City of Bellevue

RE: Pinnacle Bellevue North
Project #: 21-103195-LD; 21-103192-LP
Revision Request #10

#21-103195-LD – DESIGN REVIEW

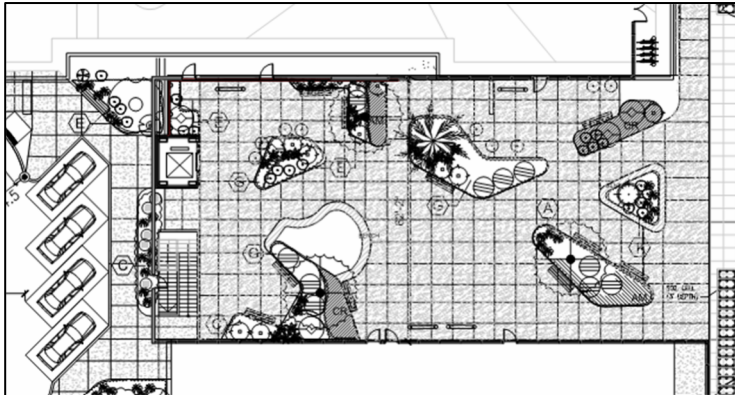
6. Weather Protection: Your departure request form shows 4 types of storefronts and demonstrates how in each location, you will have a canopy to deflect the exhaust fumes from the pedestrian areas. In looking at your proposed locations of canopies in the Departure Request for "A" Right-of-Way, Building 4 will not have weather protection. However, your elevation drawing for the east façade of Building 4 shows louver vents on top of the residential lobby doors. What is your proposed method for deflecting the odors and fumes from this exhaust vent? (image on left below is the elevation and image on right is the floor plan).

- A. On your departure request form for weather protection, instead of calling out the storefronts as type 1 to 4, show each of the elevation where there will be exhaust vents and clearly label the canopies and the elevation drawings.

- B. On your departure response, you stated that the exhaust vents will be located between the marquee and a weather protection canopy. However, I don't see in your elevation drawings where that is the typical condition.

REVISED OUTDOOR PLAZA #1 IN LANDSCAPE AND ARCHITECTURAL PLAN

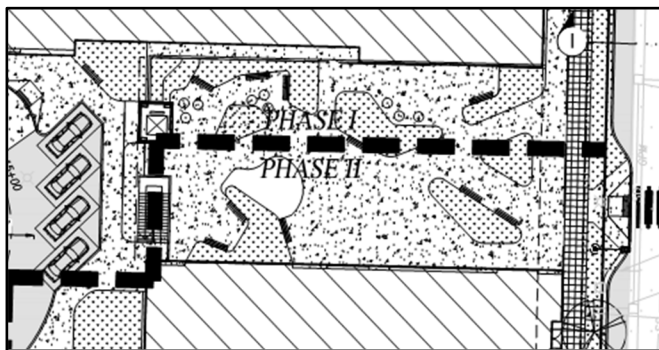
- d. **Civil Plans must be updated to reflect revisions to the architectural and landscape plans.** In addition to comment about the garage intake vent on the north property line not shown on the Civil Plans, we have found multiple inconsistencies in the information on the Clearing and Grading, Drainage and Site Plan A/B of the civil plan set. Below are examples of information on the civil plans that do not reflect the information in your landscape plan and architectural plans. It is your responsibility to do a quality check of all your plans and not just incrementally make changes to the plan sheets without consideration of other sheets that will be affected by the revision.

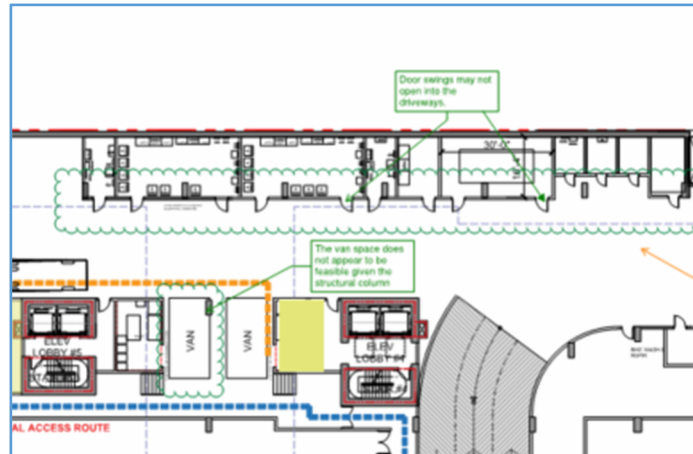
14. Tower Separation for Buildings 4, 5 and 6 above 80 feet: Your Separation Diagram, Sheet A0.12 shows separation between Buildings 4 and 5 to be 40 feet and 41.5 feet between Buildings 5 and 6. The required separation above 80 feet is 60 feet. Revise your floor plans and building elevations to meet the tower separation requirement. If this is not feasible, submit an Administrative Departure Request per LUC 20.25A.075.B.3. and staff will consider your request.

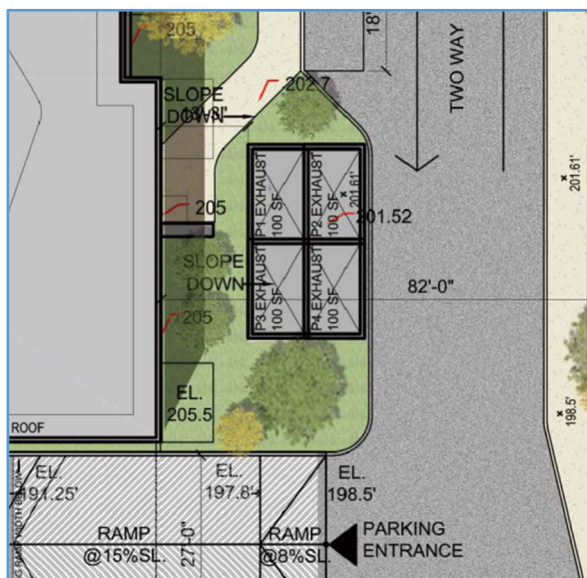
17. Garage exhaust and intake vents must be shown on all Civil Plan drawings. Site Plan B, Grading Plan, Drainage Plan only showed the exhaust vents near Building 6 and did not show the ones proposed at the north property line.

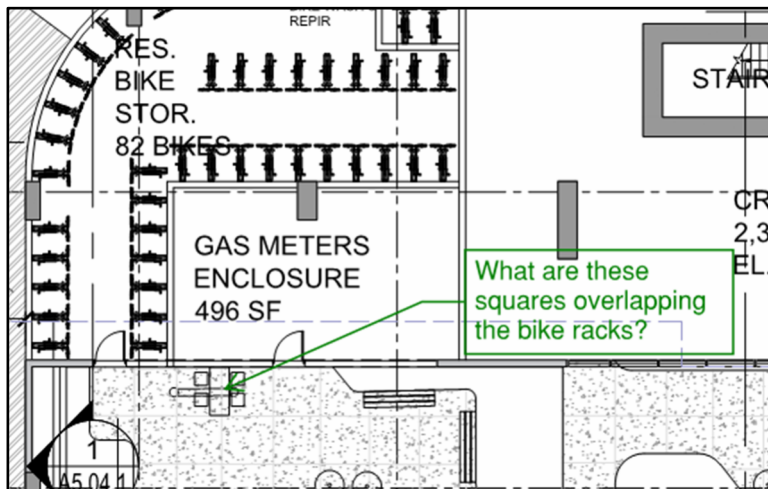
26. On Architectural Plan Sheet A0.22, include the stairs in the Through Block Connection. The public access easement to be required for the TBC will need to include both the stairs and the elevator to ensure accessibility. Confirm the width of the Through Block Connection throughout the development. The minimum width shall be 6 feet where site constraints exist, such as in front of Building 4, and 10 feet where possible.
